Department of Toxic Substances Control

June 15, 2005

Thank you for the opportunity to comment on the Draft Environmental Impact Report (EIR) for the Union City Intermodal Station Passenger Rail Project (SCH # 2003082100). As you may be aware, the California Department of Toxic Substances Control (DTSC) oversees the cleanup of sites where hazardous substances have been released pursuant to the California Health and Safety Code, Division 20, Chapter 6.8. As a potential Responsible Agency, DTSC is submitting comments to ensure that the environmental documentation prepared for this project to address the California Environmental Quality Act (CEQA) adequately addresses any remediation of hazardous substance releases that may be necessary. DTSC has the following comments on the Draft EIR:

CITY OF UNION CITY LAND USE LEGEND

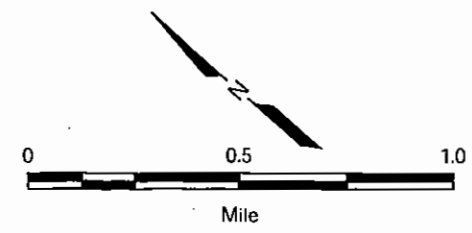
- **Figure 3.7-1 Land Use:** The Land Use Legend in this figure is inaccurate and should be corrected as follows:

08.18 The comment requests changes to Figure 3.7-1, Land Use.

Response – Figure 3.7-1 has been revised as indicated and the revised figure is included in Chapter 5, Revisions to the Draft EIR and Partial Revision of the Draft EIR.
